**MIAMI DADE TRANST – OFFICE OF CIVIL RIGHTS AND LABOR RELATIONS
FTA KEY STATION 2001 ASSESSMENT FINDINGS FROM EXIT CONFERENCE
SUMMARY AS OF DECEMBER 2002**

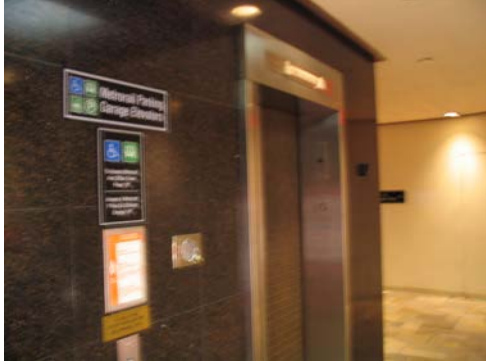
SYSTEMIC ISSUES FEBRUARY 9, 2001 ASSESSMENT	FINDINGS	CORRECTIVE ACTION	EXHIBITS	DATE ITEM CURED
	<p>platform screens or guard rails shall have a detectable warning. Such detectable warnings shall comply with 4.29.2 and shall be 24" wide running the full length of the platform drop-off. 4.29.2 Detectable Warnings on Walking Surfaces — Detectable Warnings shall consist of raised truncated domes with a diameter of nominal 0.9" (23 mm), a height of nominal 0.2" (5mm) and a center-to-center spacing of nominal 2.35" (60 mm) and shall contrast visually with adjoining surfaces, either light-on-dark, or dark-on-light. The material used to provide contrast shall be an integral part of the walking surface. Detectable warnings used on interior surfaces shall differ from adjoining walking surfaces in resiliency or sound-on-cane contact.</p>		 <p>Exhibit 15 – Southbound Platform</p>
